**FINDINGS AND RECOMMENDATION
OFFICE OF PLANNING AND ZONING
ANNE ARUNDEL COUNTY, MARYLAND**

CASE NUMBER: 2025-0001-V

Engineering and Utility Review
Variance comments for
2025-001-V
523 Point Field Drive, Millersville

DEVELOPER CONDITIONS (VARIANCE SITE PLAN)
 POINT FIELD LANDING ~ LOT 34R
 523 POINT FIELD DRIVE, MILLERSVILLE, MARYLAND 21109
 TAX PACT NO 09-086-25897/01
 ANNE ARBURN CO. DCTY MARYLAND DISTRICT 39D
 SCALE: 1" = 20'
 DATE: 12/29/2024
 SHEET 2 OF 3

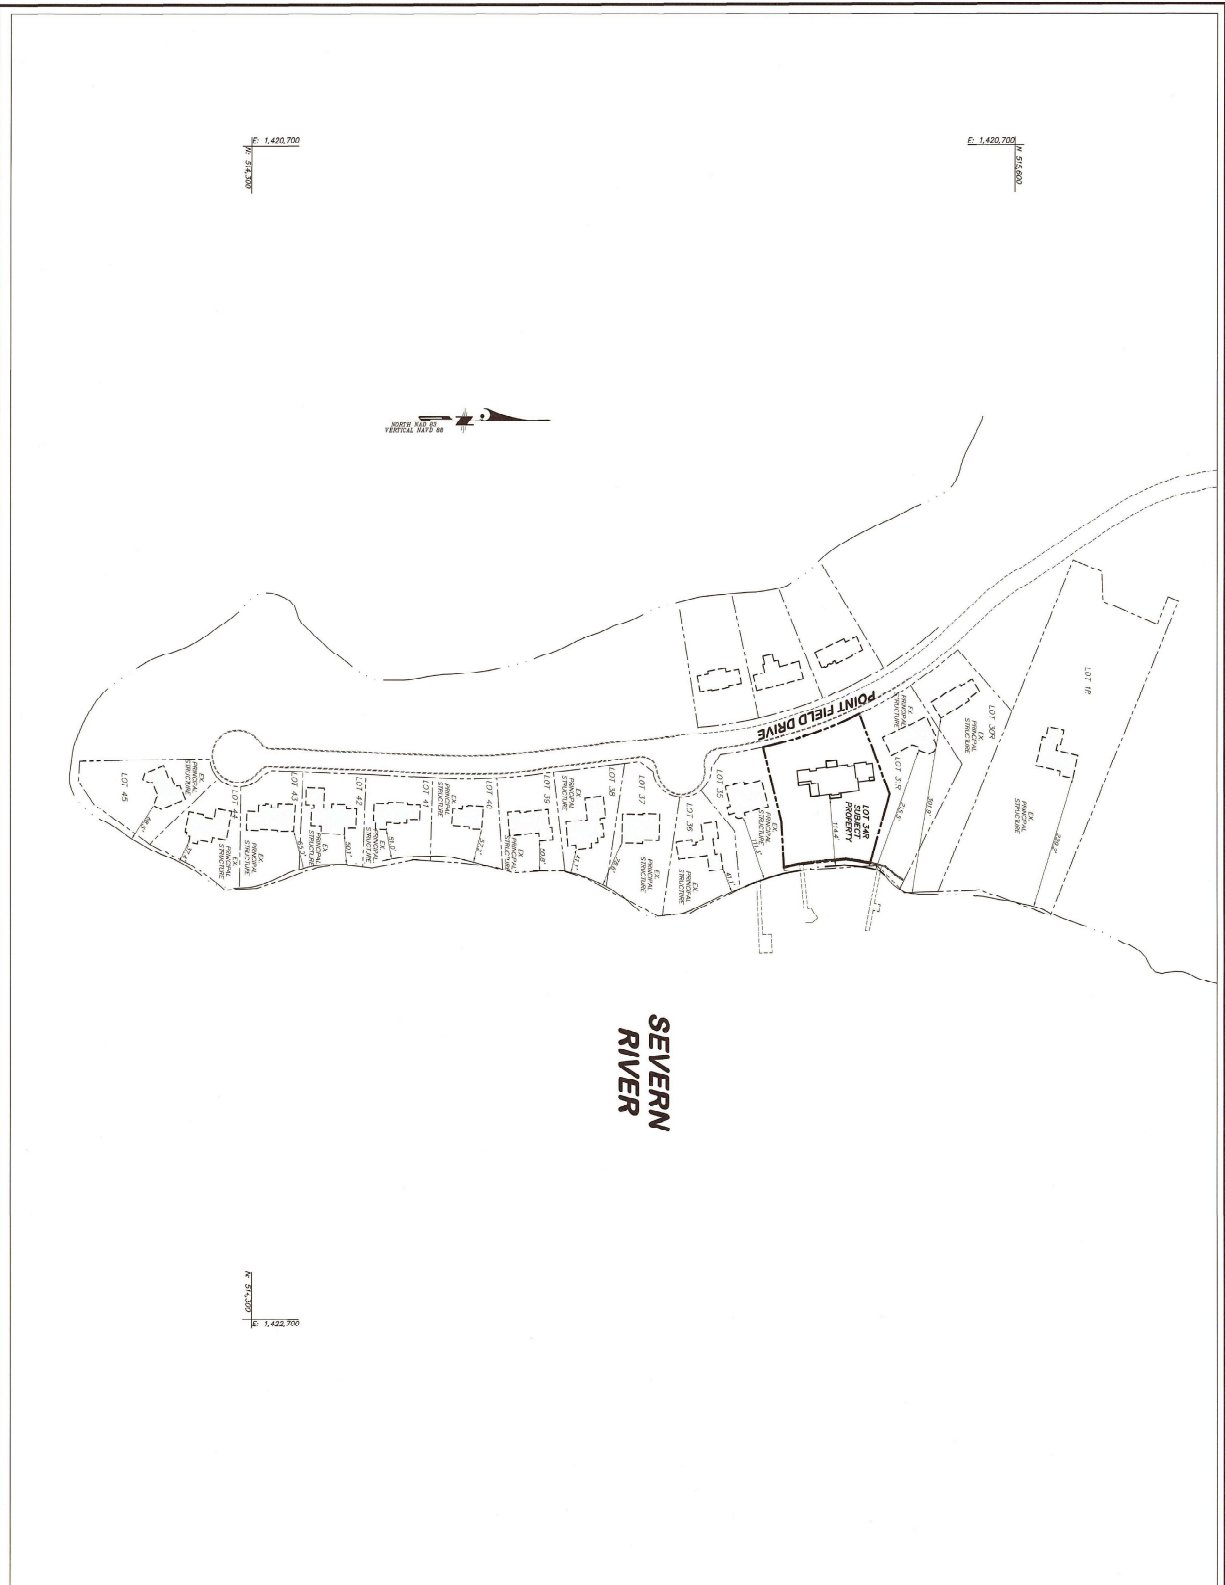
7. The shown permeable pavement is upslope of the house and garage, therefore it requires a 20-foot setback from the structures.
8. Only permeable concrete or pavers are permitted as bituminous/asphalt pavement has the risk of likely being accidentally sealed.

9. The surface elevation of the proposed Micro-Bioretention Area appears to be 9.5 per Sheet 2 of 3. The soil boring, SWM #2, appearing on the same sheet notes there is groundwater at elevation 7.75. 4 feet of separation is required between ground water and the bottom of a SWM device. Relocate the device or regrade the lot to meet the required separation distance. The SWM device can't be relocated within the 100' Buffer or within steep slopes or the steep slope buffer or other sensitive areas.

11. The existing wooden boardwalk is partially within the LOD. Is a portion of it being removed or replaced? It is not currently labeled to be removed while it extends into the proposed pool deck. Clarify what items are to be removed on the Existing Conditions Plan, as the existing house is currently the only item noted to be removed on the plan.

12. It is not clear if the swale north of the garage is intended to flow into the Micro-Bioretention Area or around it.

13. It is not clear where the Disconnection of Non-Rooftop Runoff is located. Note it must meet the criteria of both the MDE and County SWM Manuals.
14. It appears per the grading shown between the house and Point Field Drive, the drainage is to flow across the driveway. Per the Typical Drive Detail on Sheet 2 of 3, the proposed driveway is crowned preventing the runoff from flowing across the driveway and causing drainage issues.

15. Clarify what "ex. trans" is. If it is an electric transformer label as "ex. elec. trans."
16. We defer to the Planning and Environmental Reviewer(s) for the amount of disturbance to the CRZ, Critical Root Zones of the trees along the driveway disturbed by the driveway and its proposed Permeable Pavement. The surface disturbance may be approximately the same in the plan view as there is an existing driveway in the approximate same location; however, depending on the type of Permeable Pavement used to treat the runoff, the cross section of the Permeable Pavement will most likely extend deeper into the soil and root zone than the existing driveway thus affecting the trees to a greater extent than the existing condition(s).
